工程指示 / 要求簡箋 ENGINEER INSTRUCTIONS(E.I.)

工程指示編號:	EI- 8864	修改版本:	C
	HK- 0294		
工程編號:	J 861	工程名稱:	己連拿利
收件人:	生統/技術部	發件人:	細佬
工程項目:	幕牆角位	日期:	08/04/2025

J-861 已連拿利幕牆 轉角位與企料組裝

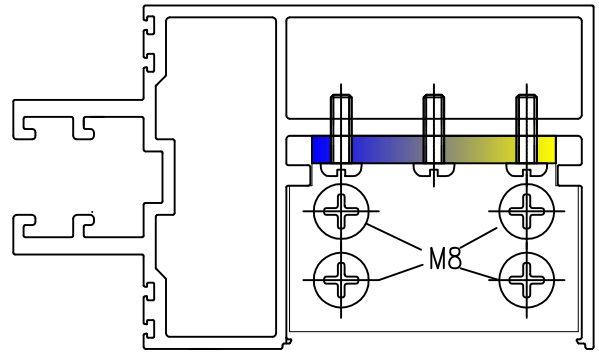
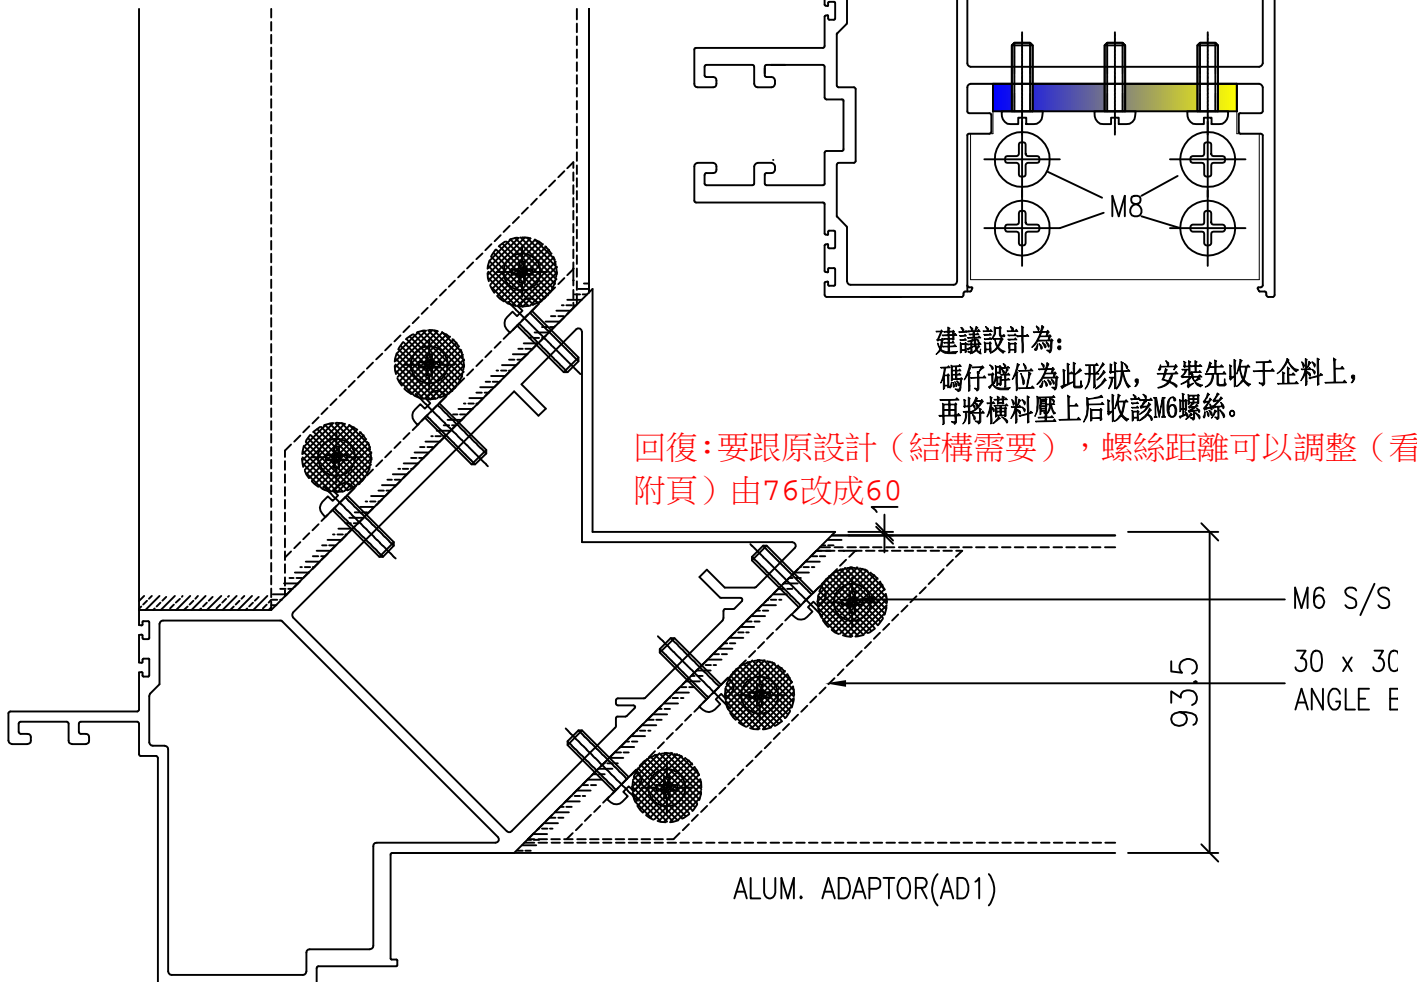
上圖為原設計：
陰影卡入

建議設計為：
碼仔避位為此形狀，安裝先收于企料上，
再將橫料壓上后收該M6螺絲。

回復：要跟原設計（結構需要），螺絲距離可以調整（看附頁）由76改成60
